Deicorp Projects Showground Pty Ltd

Response to Independent Audit 4

2 Mandala Parade, Castle Hill

Date: 11/10/2024

Photos 17 & 18: Stormwater connection works on Mandala Drive.

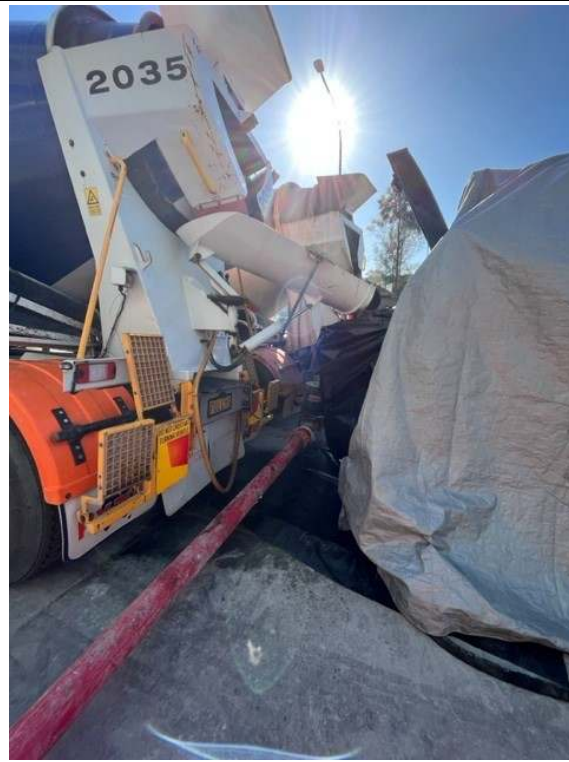
| CoA# | Summary of Non-Compliance | Recommended Action Due Date Status |
|------|--|---|
| C8 | <u>Non-Compliance</u> : Approvals for stormwater connection works underway at the time of the audit on Mandala Pde were requested but not provided as evidence. | Recommended Action : Provide a copy of Council and/or Sydney Metro approval for stormwater connection works underway at the time of the audit on Mandala Pde. Due Date : IA5 Status : OPEN |
| D40 | <u>Non-Compliance</u> : During the IA4 site inspection stormwater connection works were underway on Mandala Drive, outside the site boundary. | Recommended Action : Provide evidence that the stormwater connection works on Mandala Pde are not within the 25m rail |

| CoA# | Summary of Non-Compliance | Recommended Action Due Date Status |
|------|---|---|
| | The auditor requested evidence that the works were not within the rail protection zone, but this evidence was not provided within the audit timeframe. | protection zone, and if so, provide evidence of geotechnical engineer supervision. Due Date: IA4 Status: OPEN |
| D46 | <u>Non-Compliance:</u> During the IA4 site inspection stormwater connection works were underway on Mandala Drive, outside the site boundary. The auditor requested evidence that the works were not within the 25m rail protection zone, but this evidence was not provided within the audit timeframe. | Recommended Action: Provide evidence that the stormwater connection works on Mandala Pde are not within the 25m rail protection zone, and if so, provide evidence of written notice to Sydney Metro at least 5 business days before the excavation commenced. Due Date: IA4 Status: OPEN |

During the site inspection stormwater connection works were underway on Mandala Drive, outside the site boundary. Approvals from The Hills Shire Council and Sydney Metro were requested as evidence during the audit process. Evidence of consultation and approval from these regulatory agencies was not made available (due a change in personnel and the relevant Council representative being on leave) and will be followed-up during the next audit (IA5, February 2025).
